Project No. 07516-42-02
May 10, 2023

Subject: RESPONSE TO CITY OF SAN DIEGO REVIEW COMMENTS
NAKANO
SAN DIEGO, CALIFORNIA

- References:
1. Project Issues Report, Nakano Discretionary Project, PRJ-1076302, City of San Diego, Geology Review Comments prepared by Kreg Mills, dated April 21, 2023.
 2. *Update Geotechnical Investigation, Nakano Property, Chula Vista, California* prepared by Geocon Incorporated dated September 18, 2020 (Project No. 07516-42-02).
 3. *Addendum Geotechnical Report and Response to City of San Diego Review Comments, Nakano, San Diego, California*, prepared by Geocon Incorporated, dated February 9, 2022 (07516-42-02).
 4. *Nakano, Grading and Storm Drain*, prepared by Civil Sense, Inc., dated May 12, 2022.

GEOLOGIC MAP
 NAKANO
 CHULA VISTA, CALIFORNIA

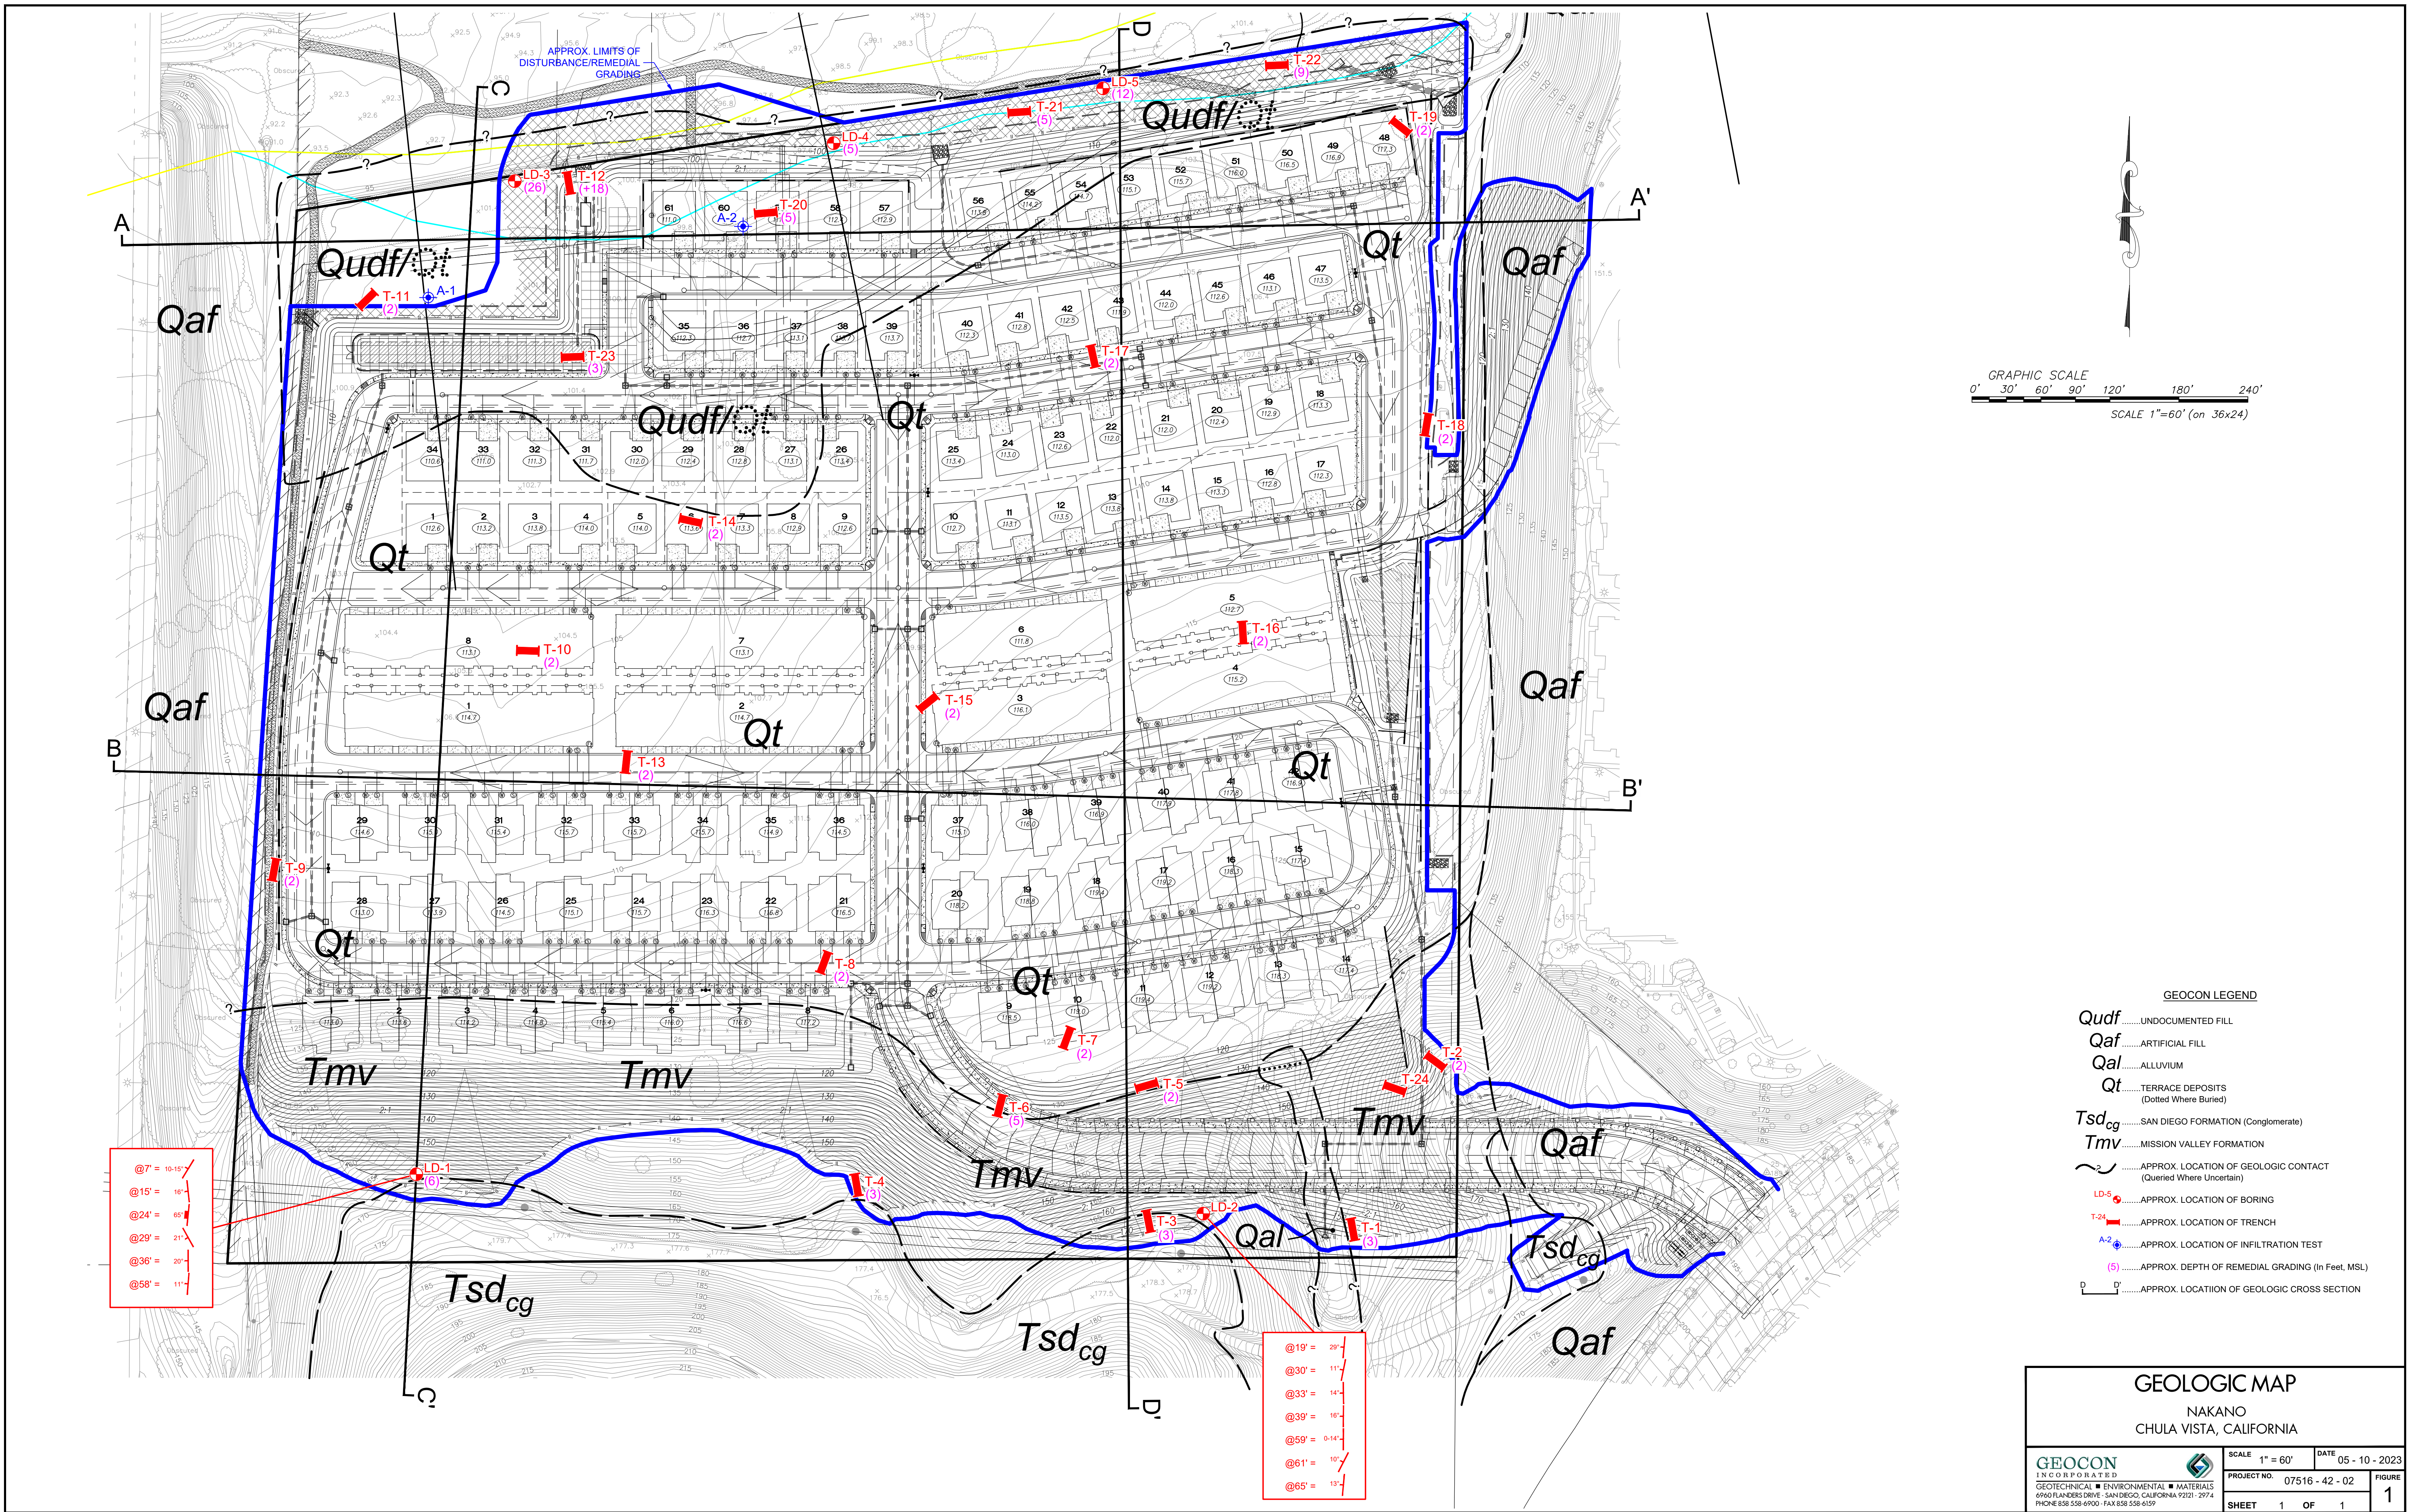
Issue 51: *The limits of the proposed development appear to have changed since the submitted report was prepared. Provide an updated Geologic Map (Figure 2) that shows the current proposed development. Circumscribe the limits of anticipated remedial grading on the updated map to delineate the proposed footprint of the project.*

Issue 52: *The project's geotechnical consultant should note that while the southern portion of the site is in Geologic Hazard Category 22 and 52, most of the site appears to be in GHC 32. Per the submitted Update Geotechnical Investigation, the northwest portion of the site is underlain by compressible surficial deposits consisting of undocumented fill, topsoil, colluvium, and alluvium that exceeds 18 feet thick and groundwater may be encountered on the north side of the property adjacent to the Otay River channel, clarify how the data from the geotechnical investigation demonstrates the site will not be impacted by liquefaction potential.*

Response: Figure 1 is the requested updated geologic map using a CAD file of Reference 4 as the base map. Figure 1 shows the proposed development and the disturbance limits and limits of anticipated remedial grading. Cross sections are provided on Figures 2 and 3.

Response: To evaluate the potential for liquefaction and groundwater impacting removals, we performed three large-diameter borings on the norther edge of the development at the locations shown on Figure 1 (Borings LD-3 through LD-5). We encountered undocumented fill overlying alluvium and terrace deposits. Seepage was encountered near a depth of 33 feet in boring LD-3. The seepage is below the expected removal bottom and within the underlying terrace deposits. Logs of the borings are appended.
